WAILUA - KAPA'A
NEIGHBORHOOD
ASSOCIATION

October 27, 2014

RE: Coconut Beach Development LLC, Waipouli – Project Design Review (TMK 4-3-2:15, 16 and 20)
SMA (U)-2006-4, PDU-2006-6, and Z-IV-2006-9

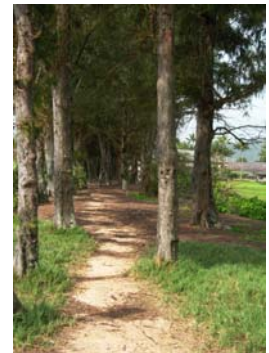
The project design affords minimal opportunity to retain important viewplanes to the ocean and mauka views of Nounou Mountain (the Sleeping Giant). Even the consulting architect admitted when describing the building mass, that several of the makai-to-mauka views were “challenged”.

This project proves how easy it is to avoid preservation of important coastal and mauka views, as shown in their Beach-Side and Street-Side perspective renderings. Considering guidelines in the General Plan and Coastal Zone Management Act guidelines to “protect, preserve, and where desirable, restore or improve the quality of coastal scenic and open space resources”, we would like the applicant to demonstrate improved compliance.

Think about why the Open District was designated along this stretch of coastline -- in part, it was to facilitate views. Nounou Mountain and the coastline are significant features in the landscape that provide a source of community pride and identity.
